Diane Conklin Spokesperson Mussey Grade Road Alliance PO Box 683 Ramona, CA 92065

June 27, 2025

# **RE: MUSSEY GRADE ROAD ALLIANCE COMMENTS ON THE 2026 TO 2028 UPDATE OF THE WILDFIRE MITIGATION PLANS OF SCE**

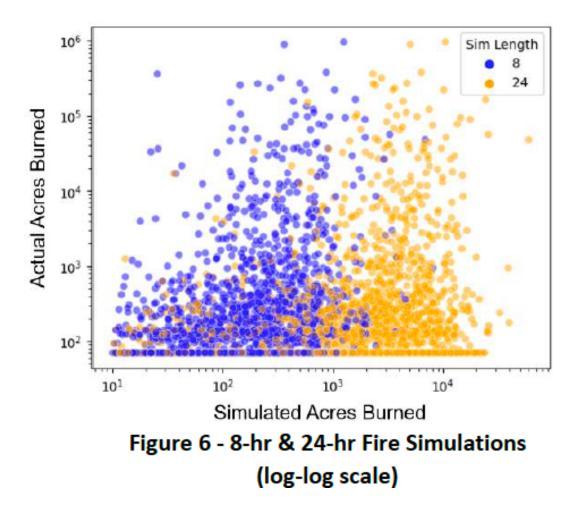
One of SCE's areas for improvement was "SCE-25U-01. Calculating Risk Scores Using Maximum Consequence Values". SCE was instructed to re-evaluate its methodology, which uses an 8 hour wildfire simulation to obtain maximum consequence values, and instead move toward using mean values. PG&E's supplemental WMP documents have provided an analysis that shows

**Figure 2** – PG&E analysis using "binned logarithmic transform" data for aggregations of fires. Technosylva simulation size is x axis, actual acres burned on the y. Garbling is in original.<sup>30</sup>

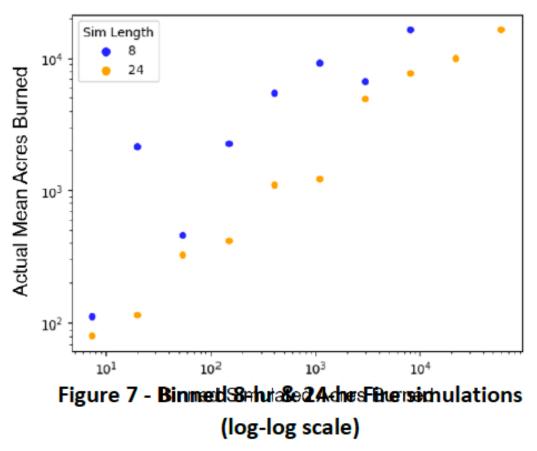
"The drawbacks of using mean value consequences in conjunction with 8-hour burn simulations is that it markedly underestimates the true risk present at various locations of SCE's system. SCE has presented a detailed explanation of this in its response to ACI SCE-23-02 in its 2025 WMP Update. Using mean value consequences based on 24-hour simulations, similar to other IOUs, presents higher risk values and may change SCE's current ranking of riskiest areas on its system. SCE is currently considering this methodology. On the one hand, it may capture more extreme events where suppression resources are limited. On the other hand, it also produces more uncertain results. SCE expects to reach a decision on the use of 24-hour simulations by the time its RAMP report is filed in 2026.

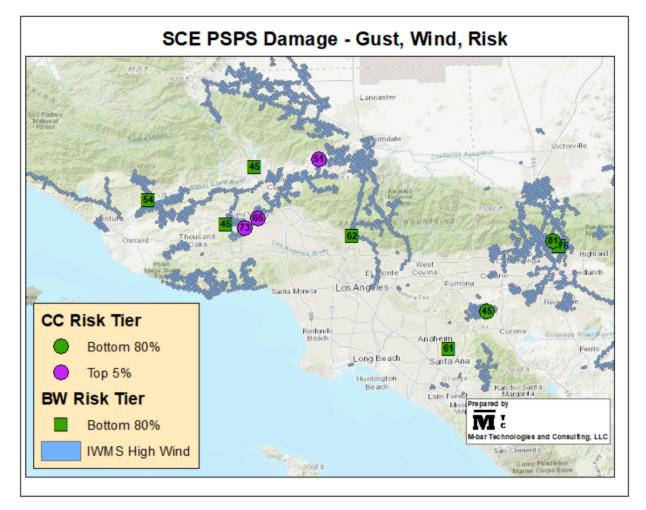
The results from the MGRA analysis are shown below. Damage/risk events are color coded by SCE's ranked risk tier for the circuit on which the damage occurred (Top 5% and Bottom 80%).<sup>56</sup> The numeric values show the maximum wind speed measured by any weather station within 3 miles of the damage within 72 hours of the damage report.<sup>57</sup> SCE's "High Wind" Severe Risk Area from its IWMS categorization is also shown. Events with nearest primary circuit designated as "Covered Conductor" are displayed as circles, whereas those designated as bare wire are shown as squares. The SCE PSPS damage report sometimes does not indicate whether the damage occurred to primary or secondary equipment, and does not describe the damage with the specificity of the ignition reports. Providing additional specificity in the damage reports, whether the damage might have led to an ignition, and whether mitigation would have prevented ignition (for CC and CC + REFCL/DCD/FCD) will further help determine whether and where shutoff thresholds might be raised further.

All but two of the instances of damage reported from the post-PSPS patrols occurred in SCE's "High Wind" Severe Risk Area, indicating that this designation is predictive of potential ignition points. However, all but three of the events occurred in the bottom 80% of SCE's risk ranking. The other three events were ranked in SCE's highest 5% risk tier, and furthermore were all associated with covered conductor circuits. One of these events occurred with local wind speeds not exceeding 51 mph, and should be investigated further as this is below SCE's threshold for shutoff of hardened circuits. A list of the events, wind speeds, and causes is shown below. No causes were specified for events from the mid-November or December shutoffs.

Figure 5 – SCE HFTD ignition rates per mile for covered conductor and bare wire from 2019 to 2024.75

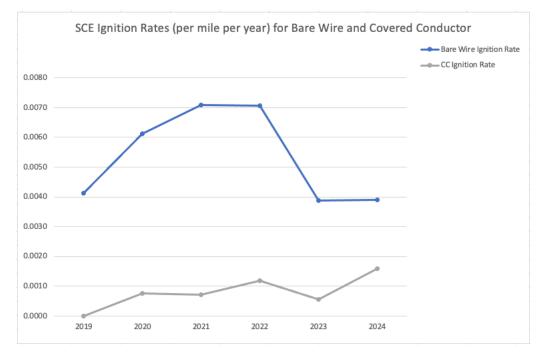
The 2024 data continues to show a high efficiency of ignition reduction for covered conductor, though not as high as in previous years, at 59% in 2024 compared to bare wire as opposed to a historical average of 80.8%. SCE explains that "2024 also saw an increase in ignitions across California due to drier vegetation after more precipitation in 2022 and 2023, which can be seen by taking the delta in the bare wire HFRA & Non-HFRA tabs irrespective of covered conductor being installed."<sup>74</sup> This is shown in the figure below:

SCE does not believe that this is due to a negative trend in covered conductor but rather that "over time, more covered conductor is installed in our system and therefore a higher number of ignitions where covered conductor is installed can occur from failures such as vehicles hitting poles, lightning strikes, and other non-covered conductor equipment failures."<sup>76</sup> Indeed, the causes of the 2024 covered conductor ignitions were animal contact (3), vehicles (2), lightning, fuse, and transformer. Two ignitions merit attention, since they might be expected to be from drivers related to high winds: one from vegetation contact and the other from an anchor/guy failure.

Since the submission of MGRA's PG&E WMP Comments and MGRA's SDG&E WMP Comments, further clarification of the definition of conductor type and reportable events was made and additional ignitions added to the history. This resulted in the predicted ignition reduction effectiveness dropping from 85% in the previous filings to 80.8% in the current filing.

Figure 6 - SCE HFRA ignition rates from Table 6.

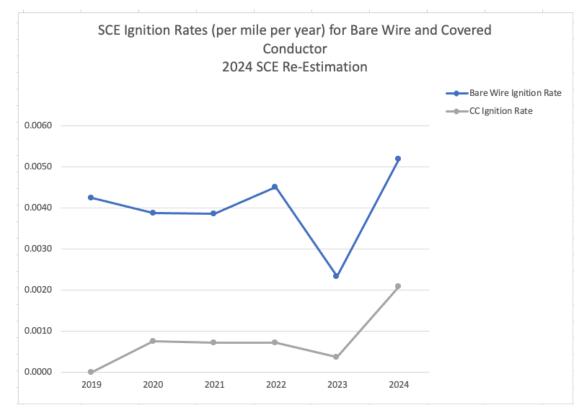
While the number of ignitions related to covered conductor circuits remains about the same as in previous data request responses, the number of reported "bare wire" ignitions in the 2020-2023 period has dropped substantially, leading to an average drop from 85% reported previously to 74%. The source of the discrepancy is not known at this time. There was some confusion in earlier MGRA data requests this year as to the definition of a "bare wire" and "covered conductor" circuit, but this was thought to be resolved by attributing ignitions to "nearest" conductor type. The discrepancy merits further examination.
